2015 Subaru WRX F4-2.0L DOHC Turbo

PITCHING STOPPER BRACKET DESIGN CHANGE

NUMBER: 12-210-17

SUBJECT: Pitching Stopper Bracket Design Change

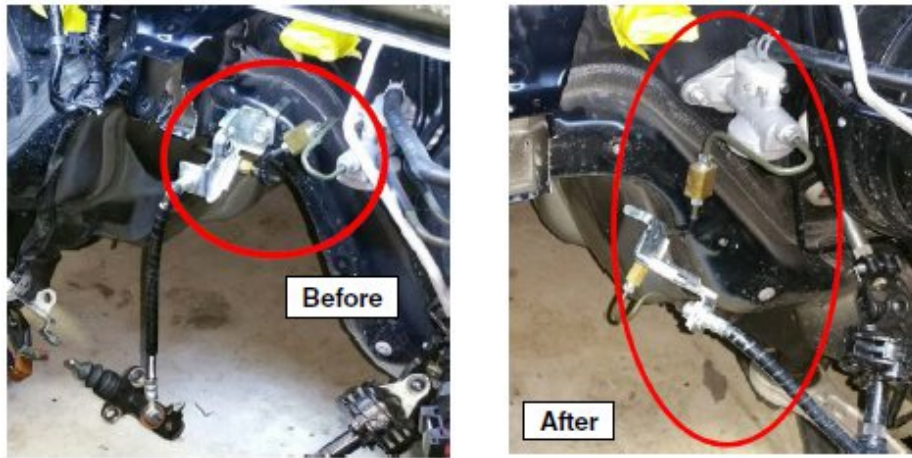
NOTE: If a new-style bracket is already in place, caution must be used on CVT-equipped models when removing the transmission to protect the insulator cover. The recommendation is to make a "cushion" using a shop cloth, tape and a piece of wire to go in between the top of the CVT and the transmission tunnel as shown. The cushion should be at least 15mm thick when crushed and the wire can be fed through a hole in the bracket to keep it in place.

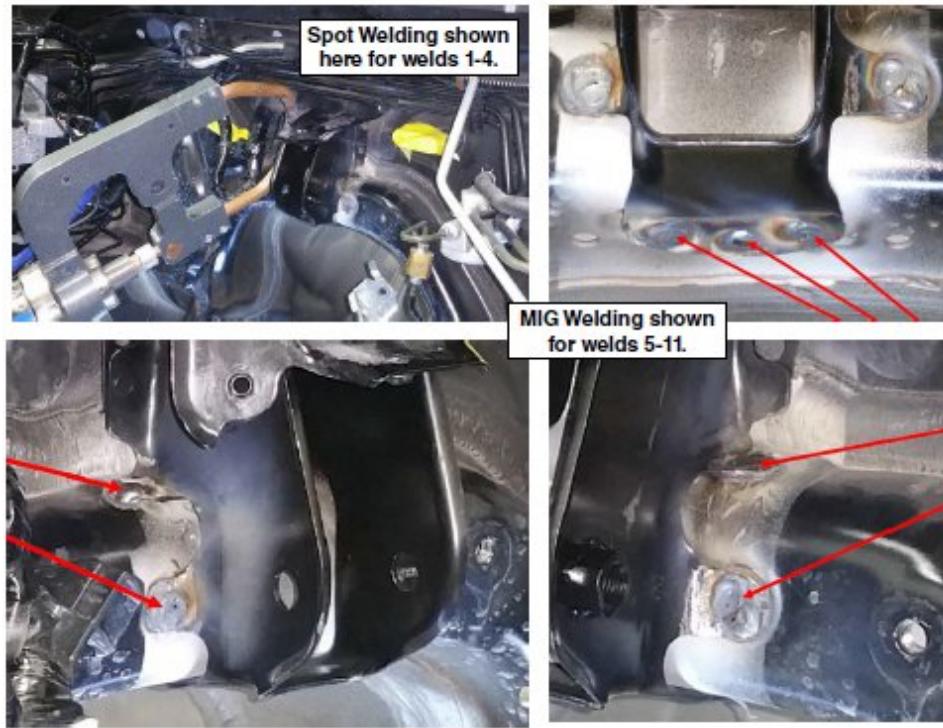
- Additional reference photos showing the welding points (5-11) are provided below.

- For the top 4 welds (welds 1-4), spot welding is recommended whenever possible as shown. In addition to having better control over the amount of heat being used, a spot welder will better replicate welds used during assembly. The recommended welding process for welds 5-11 is MIG (GMAW), Metal Inert Gas (or wire-feed). In order to minimize heat transfer and the affected weld zone, the new lower welds should be short duration or “plug” welds with good penetration to secure the new bracket to the bulkhead as opposed to a continuous weld bead which will most likely apply too much heat to the work.
- Remove the masking, confirm final fit and alignment of the new bracket is correct (no gaps) and proceed with welding.
